REMARKS

Amendments to the drawings**In the Drawings:**

Proposed amendments to FIG. 1-4 and 7 are provided herewith. Enclosed are 5 sheets of Annotated Mark-Up Drawings and 5 sheets of clean as-amended Replacement Sheets, wherein FIG. 1-3 have the text “(Prior art)” added, FIG. 4 has the text “(Background art)” added, and FIG. 7 has the reference 20 replaced with the reference 68.

FIG. 3

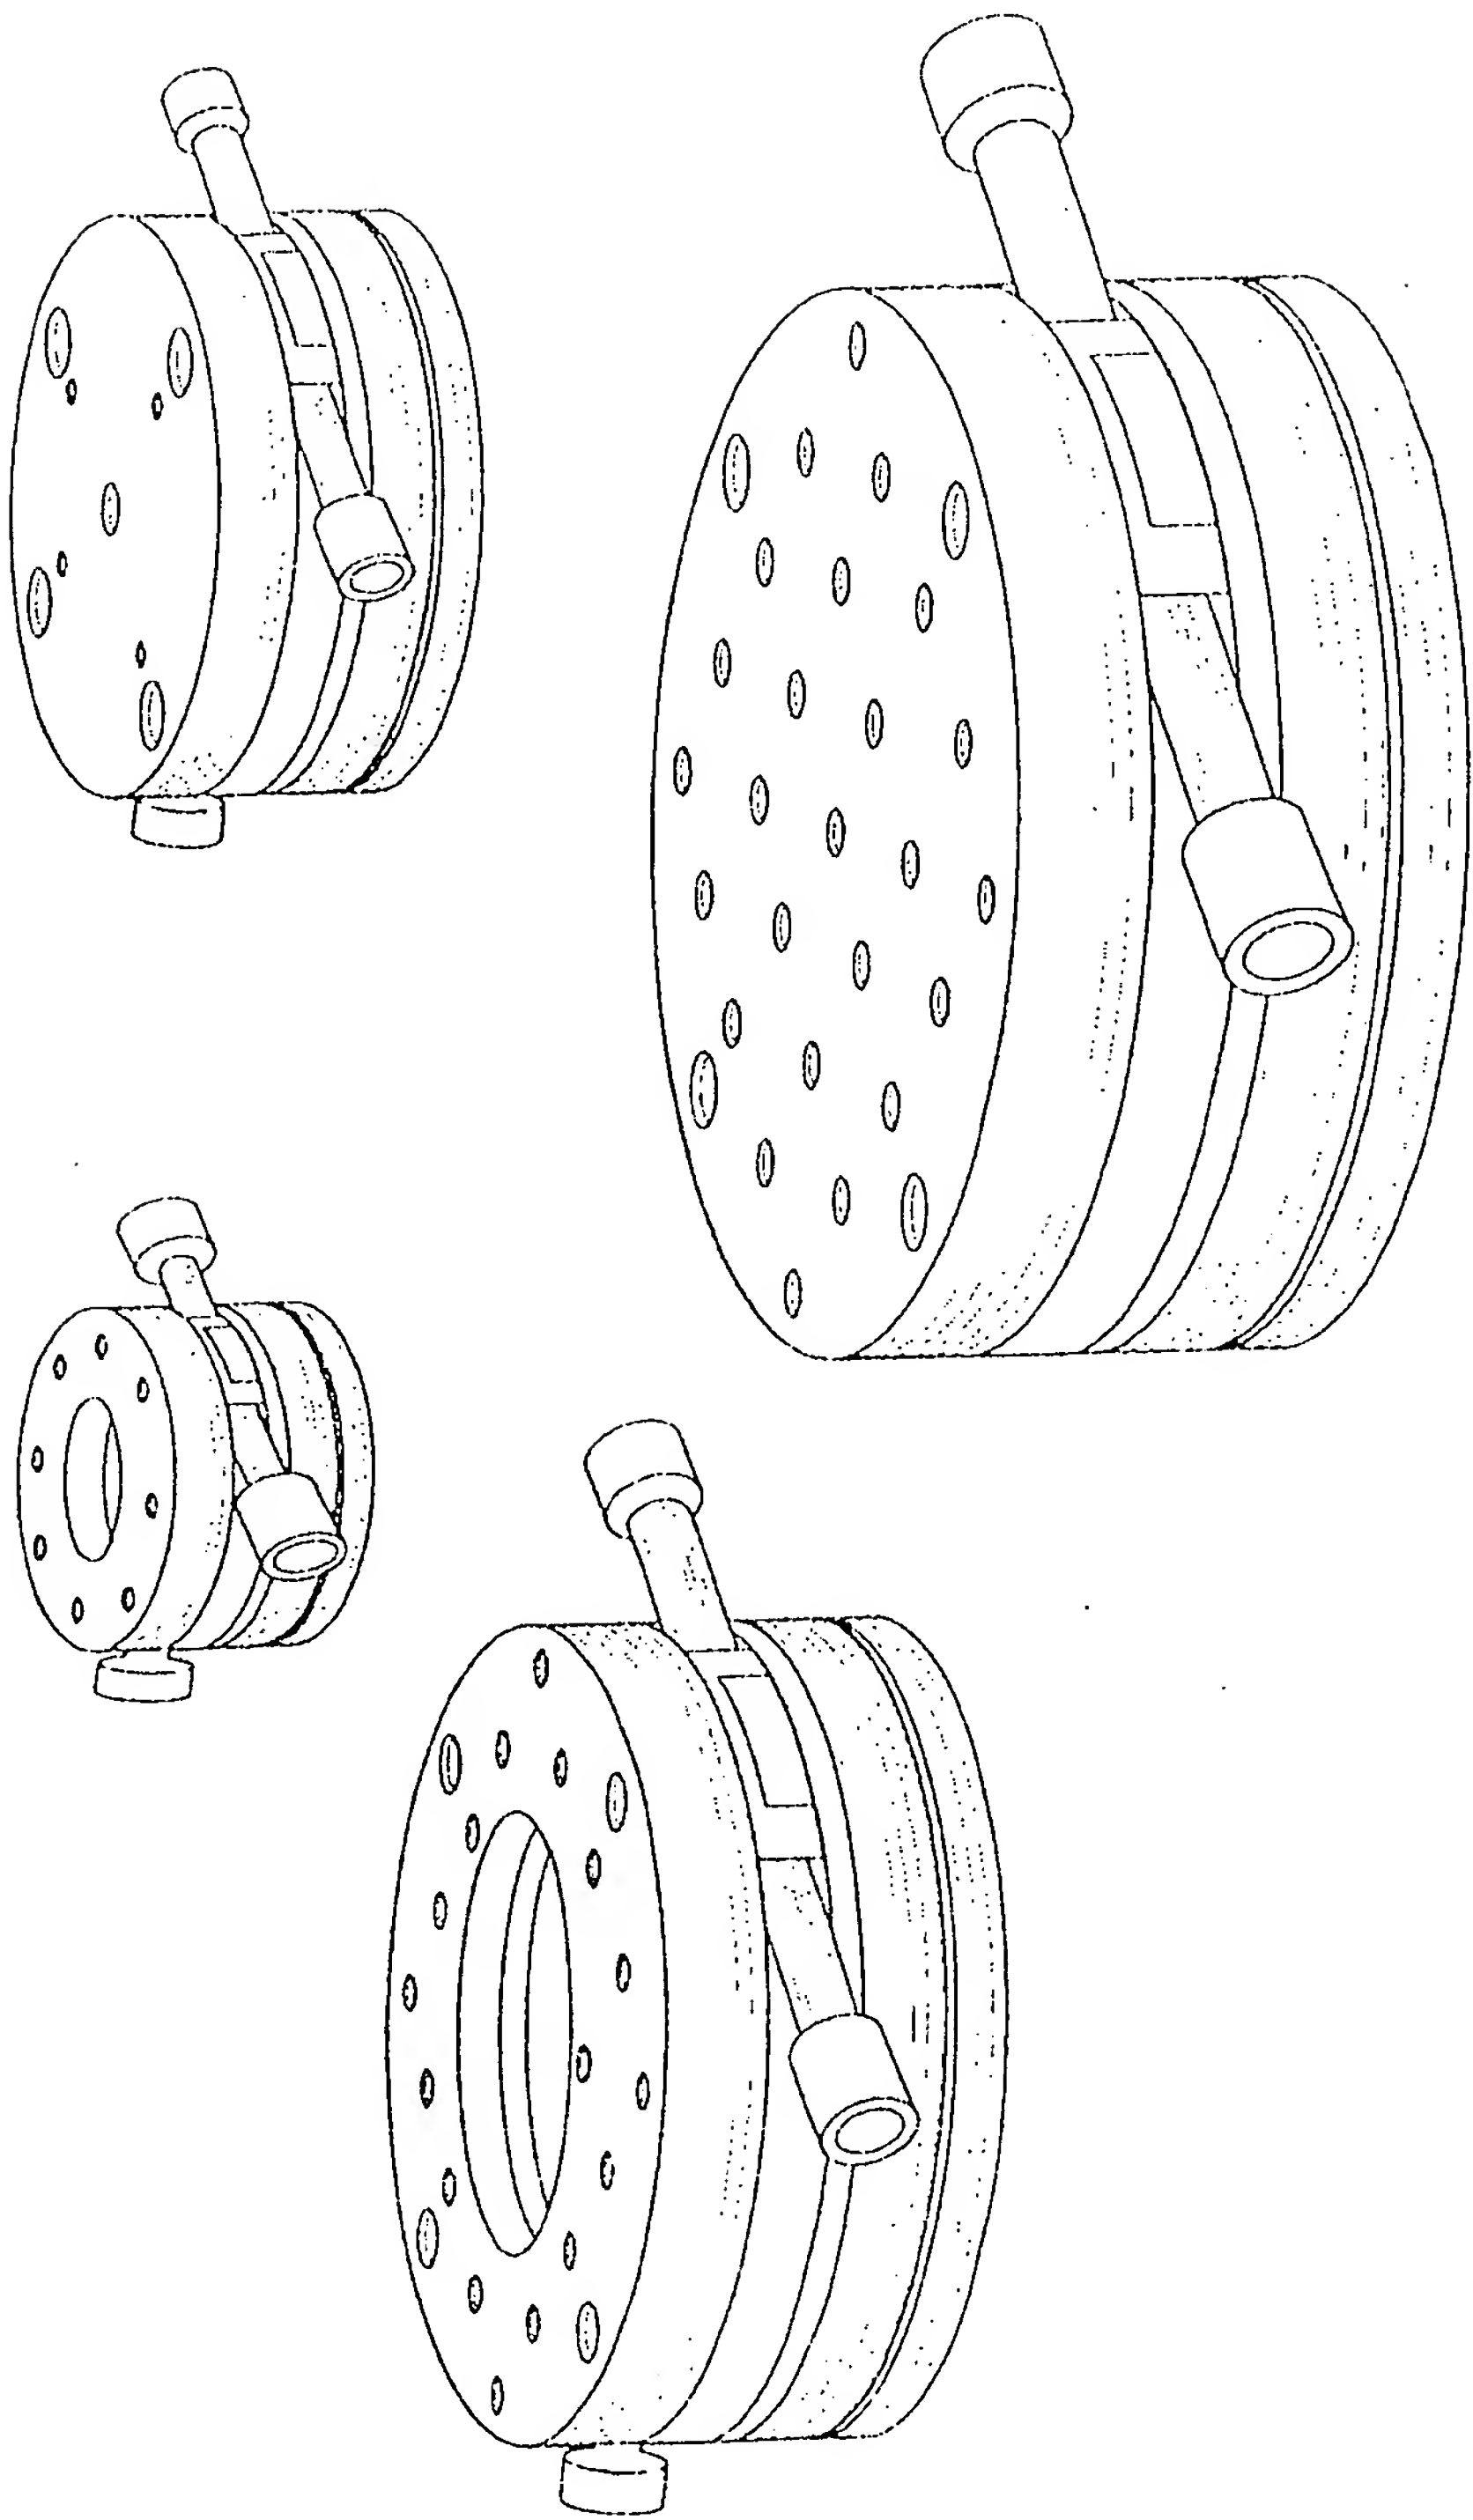
We respectfully ask entry of the proposed amended versions of FIG. 1-4 enclosed herewith. As filed, FIG. 1-3 inadvertently failed to include the text “(Prior art)” and FIG. 4 inadvertently failed to include the text “(Background art).” These amendments will bring the figures into conformity with the text in paragraphs [0014]-[0017] of the specification.

~~(Prior art)~~ Added

FIG. 4
Rotary stage with mechanically engraved scale
(Background art)

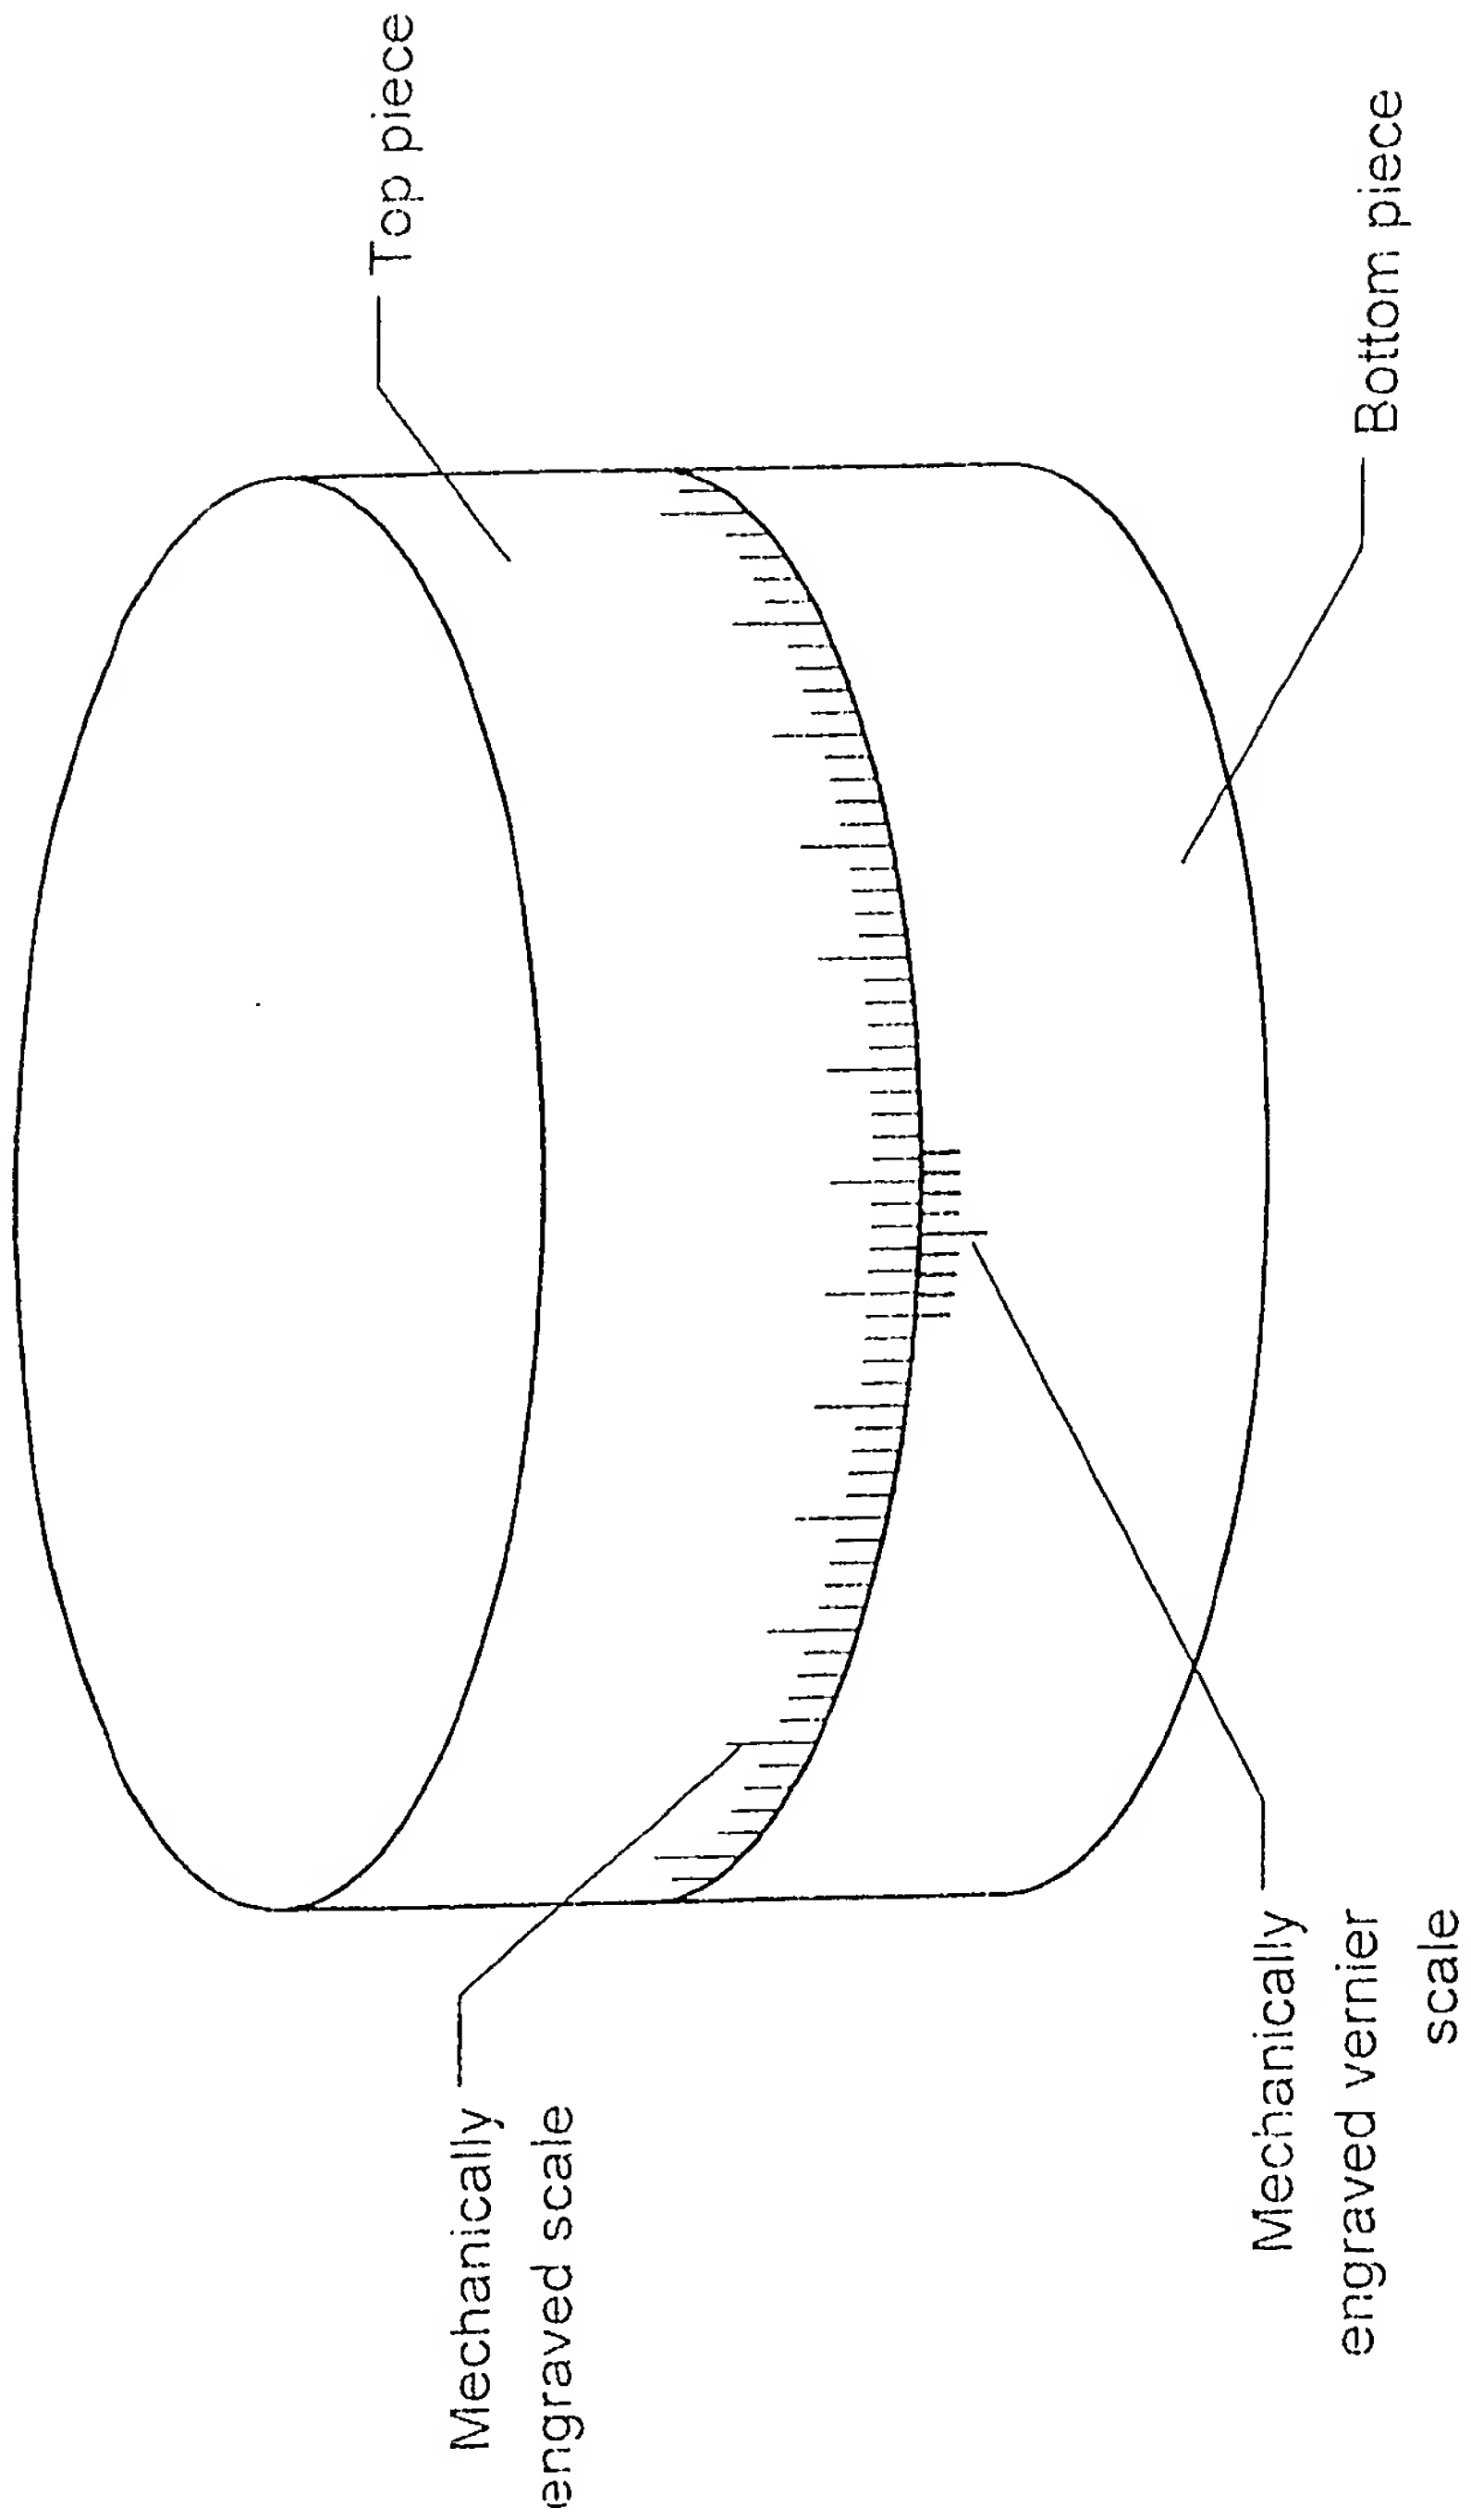
Added

FIG. 7
Rotary stage equipped with digital scale disk

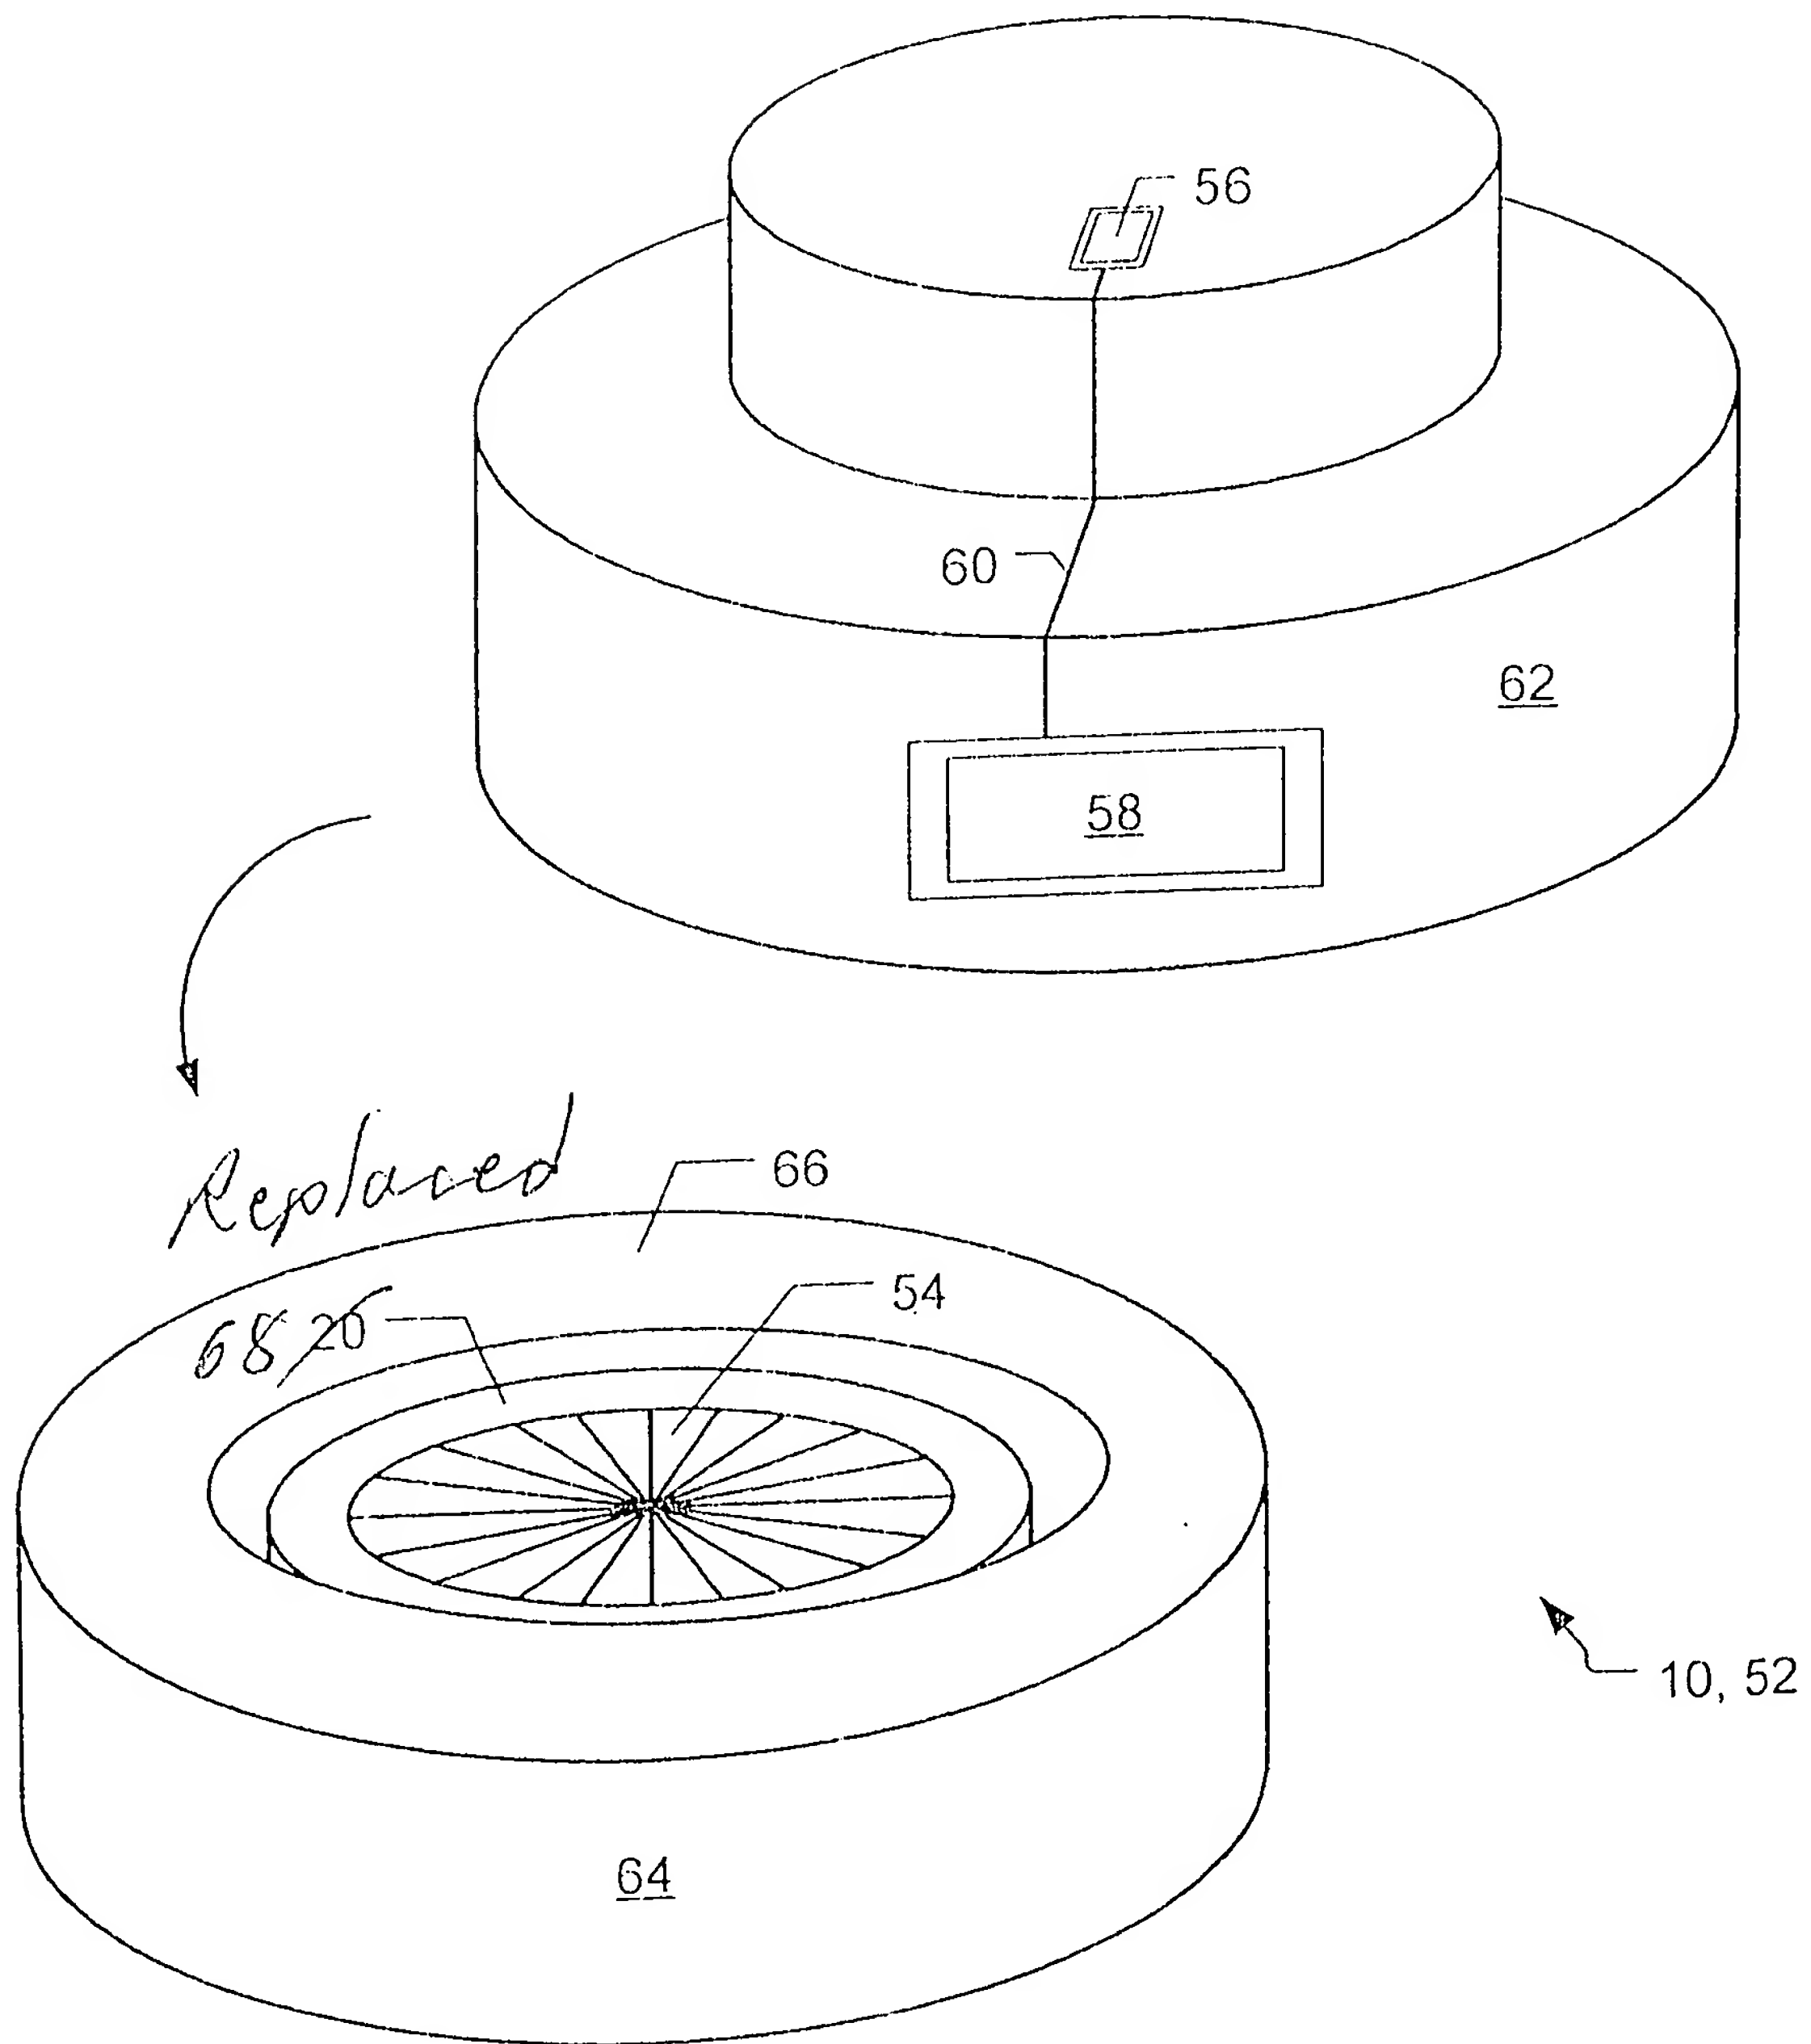
The Action here states, “*The drawings are objected to ... because they do not include the following reference sign(s) mentioned in the description: “68”*” This objection is well founded and corrective amendment is made herein.
